Subject: **Response to Portion of NRC Request for Additional Information Letter No. 148 Related to ESBWR Design Certification Application – Design of Structures, Components, Equipment, and Systems – RAI Number 3.9-160 S02**

1. Response to Portion of NRC Request for Additional Information Letter No. 148 Related to ESBWR Design Certification Application – GDCS Squib Valves – RAI Number 3.9-160 S02

RAI Number 3.9-160 S02

Figure 6.3-2. ~~(Deleted)~~ Typical GDCS Squib Valve

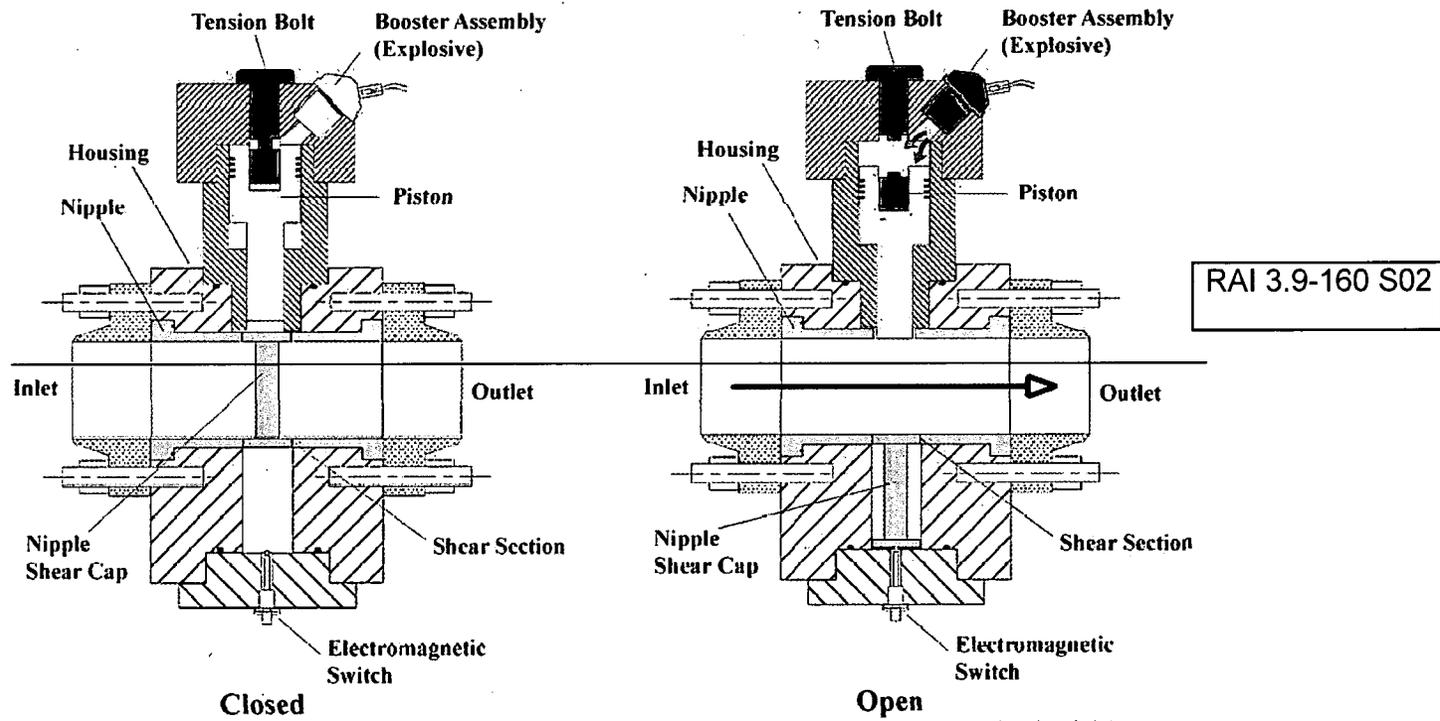
- d. Specific valve designs have not yet been selected and qualified for most ESBWR safety-related applications, including the GDCS injection and deluge squib valves. DCD Revision 4, Figure 6.3-2 is a figure of a typical squib valve that was thought to meet the requirements for the GDCS squib valves. However, after further evaluation, this design may not be able to meet GDCS squib valve requirements because, as suggested in paragraph d of this RAI supplement, the piston may block flow and/or the shear cap may not fully clear the flow stream following valve actuation. Accordingly, this figure will be removed from the DCD.

~~Illustrated in Figure 6.3-2 is a typical squib valve design that satisfies GDCS system requirements. This valve has similar design features to the ADS depressurization valve.~~

DCD Tier #2, Section 6.3.2.7.2 and Figure 6.3-2 will be revised in Revision 5 as shown in the attached markup.
